PHASE 2 REPORT

*Fernald Environmental Management Project
Critical Analysis of Operable Unit 4
Vitrification and Potential Alternatives*

*Prepared by:
US Army Corps of Engineers
for the US Department of Energy
Office of Environmental Management*

August 1, 1997

PROPOSED SILO
RADON CONTROL PLAN

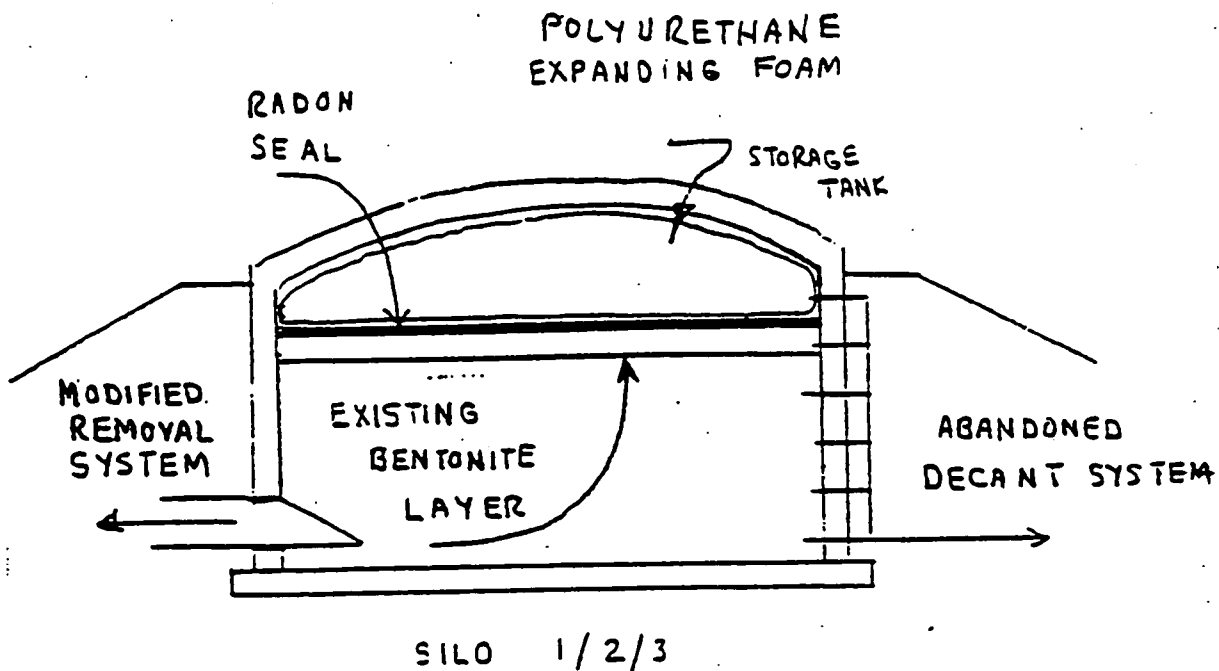
Install superstructure, cut hole in silo dome, insert pump and robotic assistant, design and install new radon capture system, and then add water to dilute to 20% solids for pump out from the top.

Foam top of tank above the bentonite clay cap with polyurethane to provide a positive seal and prevent radon escape from the top. The polyurethane foam will also be engineered to provide additional structural support for the tank top.

Cut hole in either the side or bottom of the silo and if possible remove the sludge without addition of any water. If equipment to remove the waste as is cannot be found, then minimize the amount of water added to the barest minimum. Process the sludge using either vitrification or cementation at the highest possible solids content rather than processing as a 30 to 40% solids slurry.

Instead of building an elaborate system to add water to slurry the waste, it is recommended that the concept be reengineered to remove the material with little or no addition of extra water. By removing the sludge from the bottom side of the silo using either an auger, cement pump, or other solids handling equipment, a minimum of \$20M can be saved.

CURRENT SILO RADON CONTROL PLAN

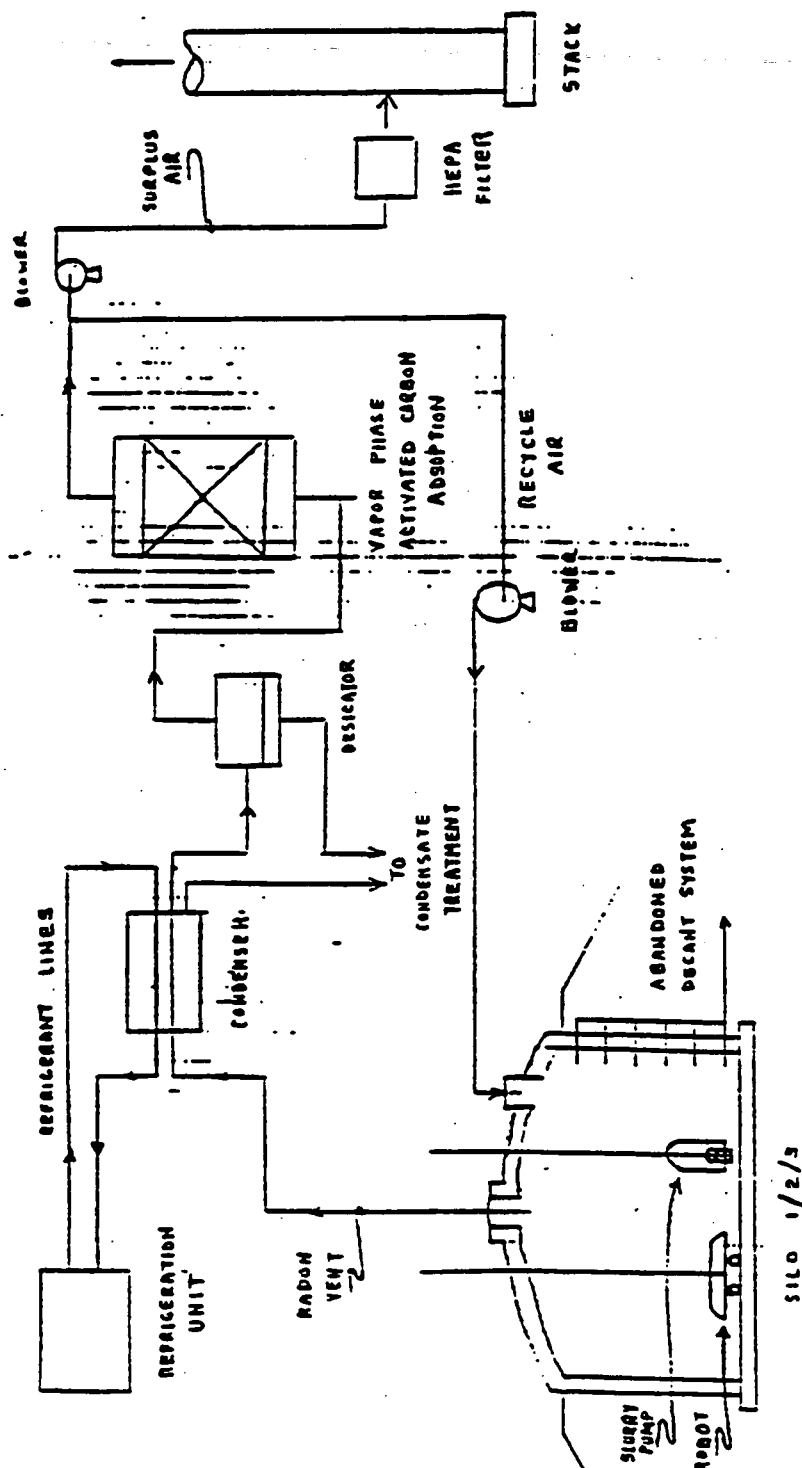
Two new emissions control systems were included in the original design. The more complex system was for treatment of process emissions from vitrification of the contents of Silos 1 and 2. The simpler system was for control of emissions from untreated material stored in Silo 1. In addition, the site plans to renovate the existing Silos 1 and 2 radon system to reduce worker exposure during work near the silos prior to treatment.

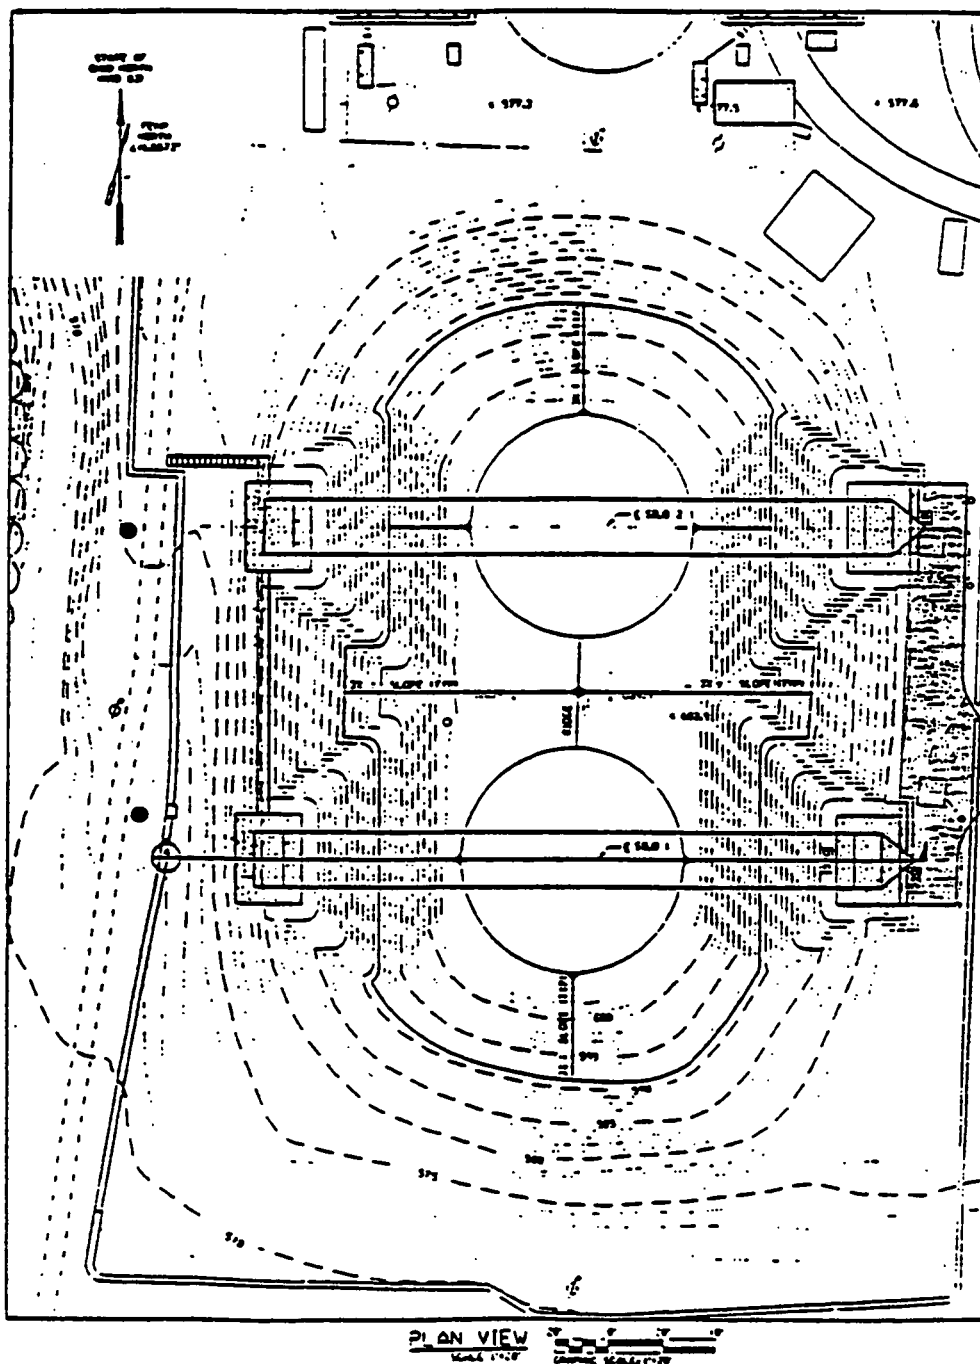
One truss (superstructure) was to be built over each silo containing K-65 waste (i.e., silos 1 and 2). See backup sheet for design. These superstructures were to provide a platform from which to work and lower equipment (pump, Houdini, etc.) into the silo.

Use a single tower crane to access both silos for waste retrieval. The crane can be used to install, support, and remove the Marconoflow pump and other equipment.
